RECEIPT DATE: 11/6/15 **ONSITE SEWAGE DISPOSAL SYSTEM** P 5 57448

PROPERTY ADDRESS: 11030 Fuzzy Hollow Way, Marriottsville, MD

BAT Plan
Low Pressure Dosing System Report

SITE PLAN FOR BAT INSTALLATION

From: Williams, Jeffrey
Sent: Thursday, September 10, 2015 1:26 PM
To: Paul Sill (paul@sillengineering.com)
Subject: 11030 Fuzzy Hollow BAT plan

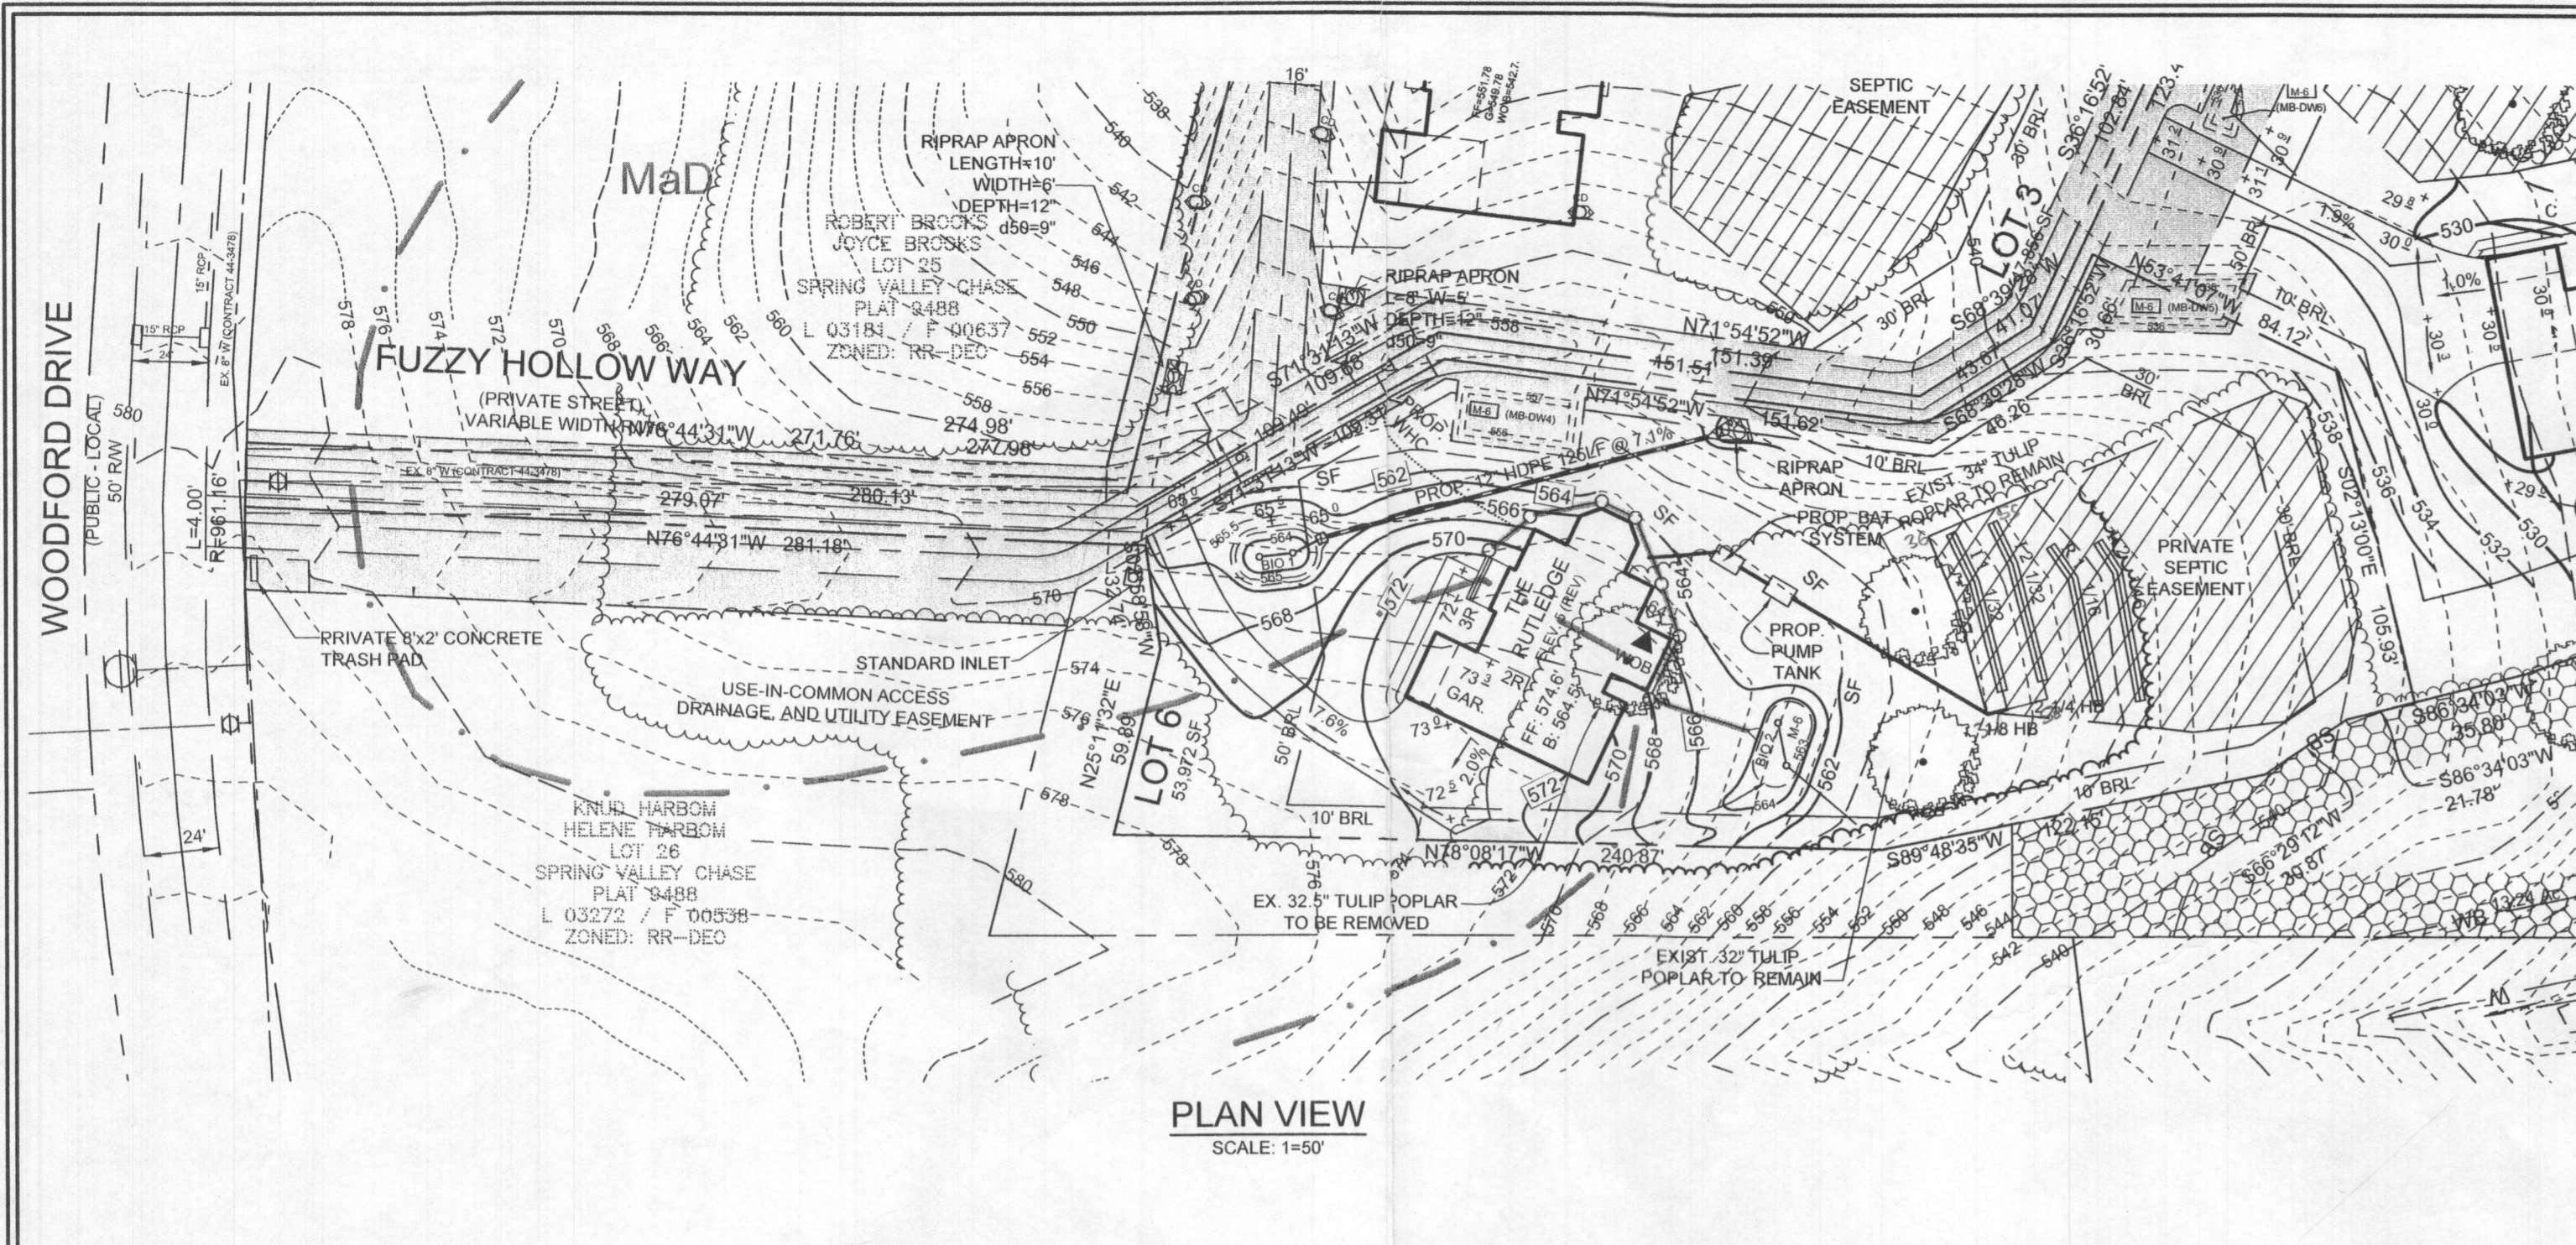
I've reviewed the BAT plan for 11030 Fuzzy Hollow and see one issue in need of correction. On the LPD design chart, you list the lateral length as 52' for both laterals, but the true lateral length will be a ½ hole space shorter than that. The rest of the chart is accurate. The correct lateral length for lateral 1 is 48.75' and for 2 is 49.1'. Would you like to revise or do you want me to redline it? Thanks

I've reviewed the BAT plan for 11030 Fuzzy Hollow and see one issue in need of correction. On the LPD design chart, you list the lateral length as 52' for both laterals, but the true lateral length will be a ½ hole space shorter than that. The rest of the chart is accurate. The correct lateral length for lateral 1 is 48.75' and for 2 is 49.1'. Would you like to revise or do you want me to redline it? Thanks

Thanks for catching that. You can make that change.
